Report: TAB Report
Function: Test, Adjust, & Balance
Date: 01/28/2026
Completed By: National TAB

02-16-26 WHATABURGER #1687 LUTZ, FL

Project Summary

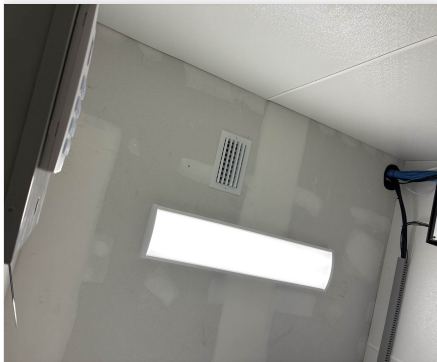
Issue Name : Additional Diffuser - RTU 3 office
Description : An additional diffuser was installed in office. There was an existing supply flex duct run blowing above ceiling in which the MC tapped into. Currently, damper is fully closed and grill reads 75 CFM. Unable to balance without a CFM target. Recommend engineer review.
Created By : National TAB **Assigned To :** National TAB - Will Turnbough
Status : Open
Priority : Urgent **Asset Tag :**
Originated Date : 02/19/2026 - Jackson Gunnels - National TAB

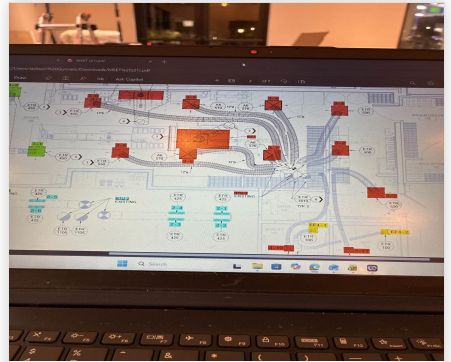
Issue Name : Exhaust fans - Incorrect Locations
Description : Exhaust fans are mounted on wrong curbs. Unable to balance fans in current state. EF-1 (larger fan) also leaks around curb.
Created By : National TAB **Assigned To :** National TAB - Will Turnbough
Status : Open
Priority : Urgent **Asset Tag :**
Originated Date : 02/19/2026 - Jackson Gunnels - National TAB

Screenshot of the GRD marked up with supply and return traverse locations for RTU-1 (Add picture here)

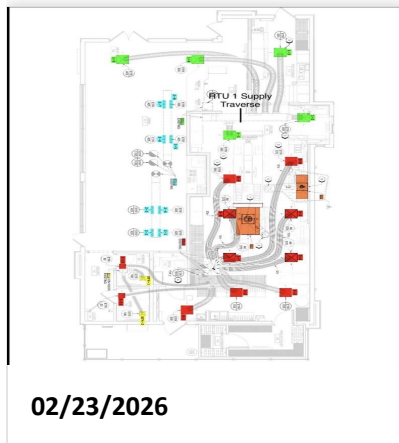
Return traverse not possible.

Asset: RTU-1

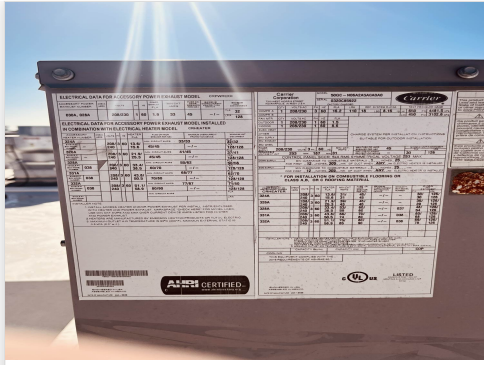
*Unable to traverse return

Asset: RTU-3

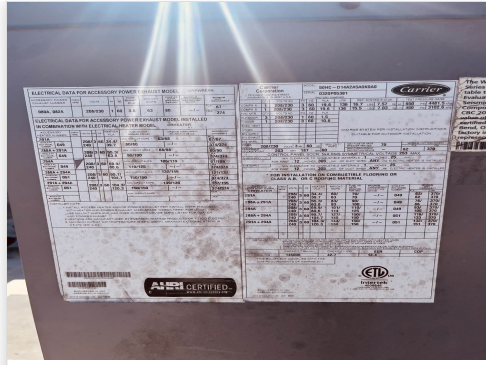
Notes:
Fan sheave sits further out than motor sheave
